## IDAP REPORT

9 Merley Road STRATHFIELD
<b>Property:</b>	Lot 15 DP 19348 DA2021.336
<b>Proposal:</b>	Demolition of existing structures, construction of a two-storey dwelling house, in-ground swimming pool with spa and ancillary landscaping.
<b>Applicant:</b>	A Chandrahasan
<b>Owner:</b>	A & S Urutherakumar
<b>Date of lodgement:</b>	14 January 2022
<b>Notification period:</b>	31 January – 14 February 2022
<b>Submissions received:</b>	1
<b>Assessment officer:</b>	L Fanayan / J Gillies
<b>Estimated cost of works:</b>	\$1,331,588.00
<b>Zoning:</b>	R2-Low Density Residential - SLEP 2012
<b>Heritage:</b>	No
<b>Flood affected:</b>	Yes
<b>Is a Clause 4.6 Variation Proposed:</b>	No
<b>RECOMMENDATION OF OFFICER:</b>	REFUSAL

**Figure 13 – Original First Floor Plan**

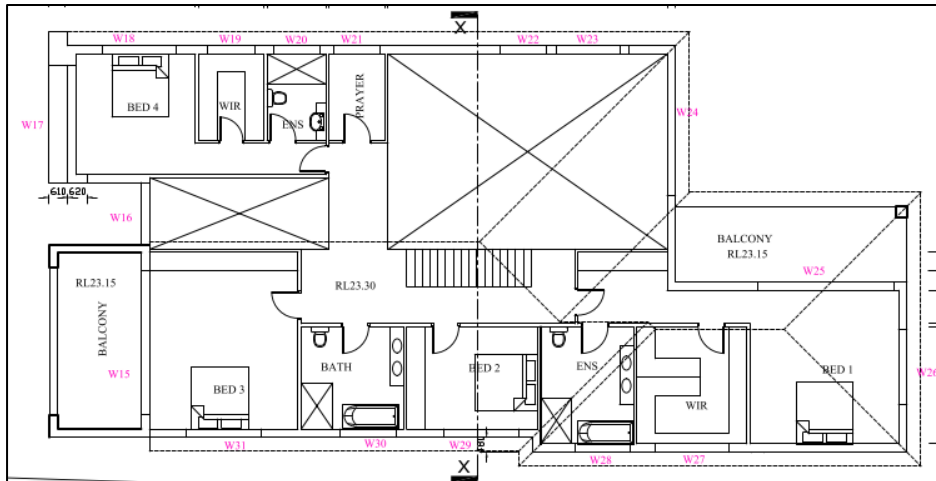
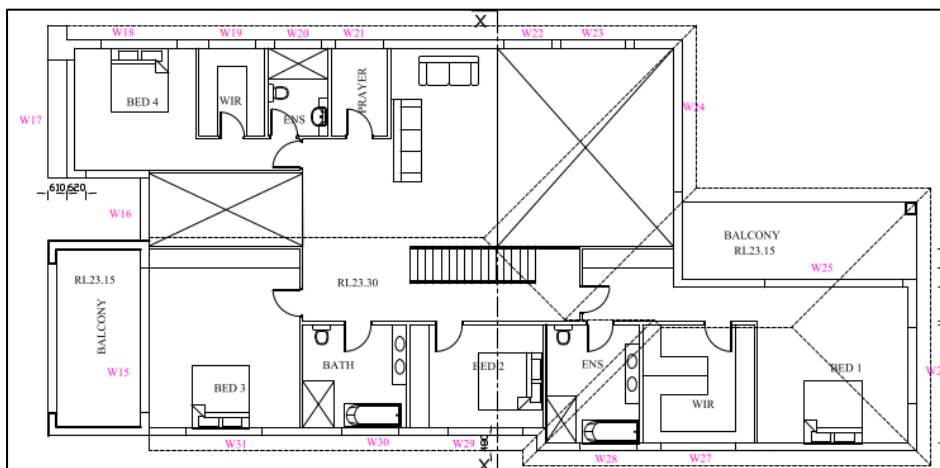
As outlined above, the proposed dwelling is inconsistent with the objectives of floor space ratio objectives under SLEP 2012. SCDP 2005 outlines that floor area calculations are to include void spaces. Council exercises reasonable allowances in the use of void spaces, however in this case the void spaces on the first floor result in an increase of 23% or nearly an additional quarter, with the first floor GFA measured at 199.72 and void spaces totalling 46m<sup>2</sup>.

Of particular concern is the rear void which does not translate into any visual relief to the northern elevation, only adding to the overall bulk and scale of the development.

The Applicant was advised of the excessive use of voids in the RFI issued in March. The resulting amendments did not change the footprint of the building or first floor total area, rather the void was reduced and floor area increased (refer images below).

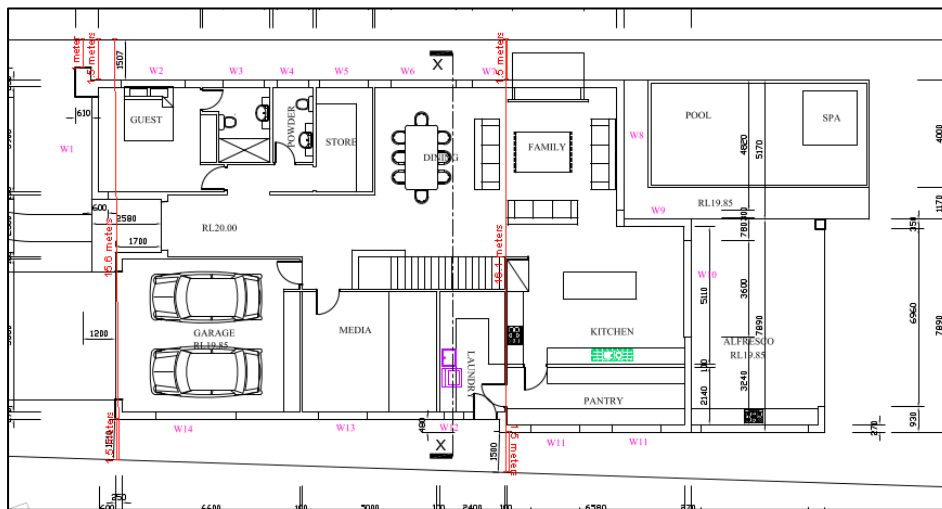
It is also noted that the lack of a long-section requires an assumption to be made regarding slab thickness and floor to ceiling heights for the portion of the building in front of the void, as this area is not shown on the section provided, which cuts across the short section of the dwelling. In this regard, it is considered that insufficient information has been submitted with the Application.

**Figure 16 – Proponents Landscape Area Calculations**

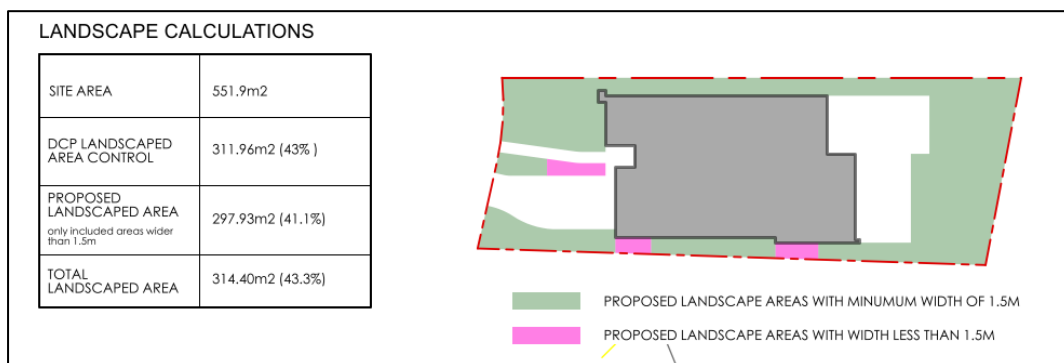
It is noted that the Applicants calculations show a total landscaped area of 297m<sup>2</sup> as shown below. These calculations represent greater non-compliance. It is also noted that the Landscape measurements show certain portions of the side setback as less than 1.5m wide, which is contrary to measurements on the Architectural Plans.

**Figure 17 – Proposed front fence**

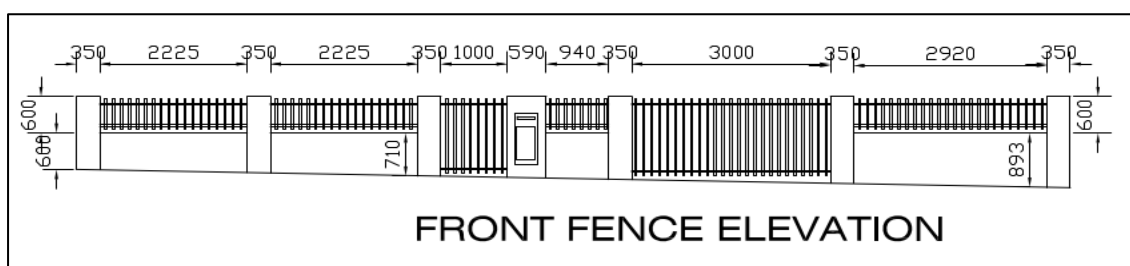
The proposed front fencing is non-compliant with SCDCP 2005 which requires the solid component to be no higher than 0.7m above natural ground level and topped by an additional maximum 0.8m high (maximum) open timber picket, wrought iron, palisade or similar element.

The proposed front fence incorporates a solid component 0.893m in height towards the eastern end and is non-compliant with the requirement.
